NHTSA Recall Number: 21V541

IMPORTANT SAFETY RECALL

Subject: SMART-STEER 2.0 Bolt-On Steer Arm Reinforcement Welds

DETAIL A
SCALE 1 : 4

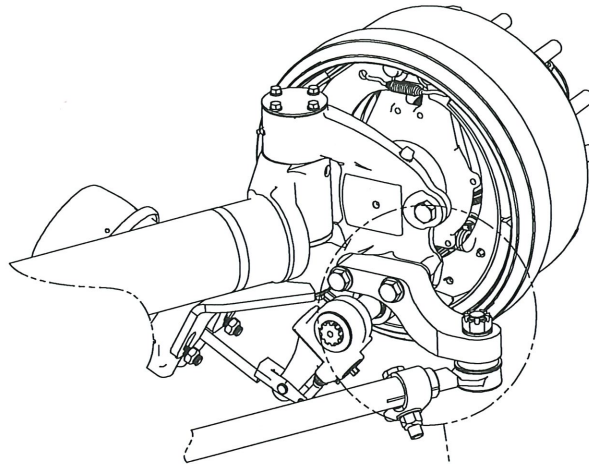
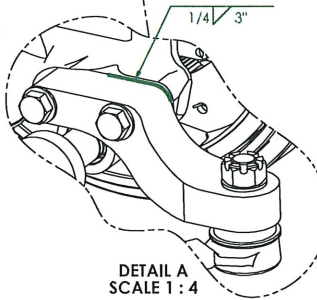
1. Visually inspect steer arm bolts and washers for mechanical tightness and replace if necessary.
2. Ensure the steer arm bolts are torqued to 400 Ft. Lbs.
3. Place welds as shown on page three of this bulletin. If you would like a copy of engineering drawing 750049, please contact one of the service technicians listed below.

NOTE:
TURN KNUCKLE AT FULL TURN TO
GAIN ACCESS TO STEER ARM
AND WELD
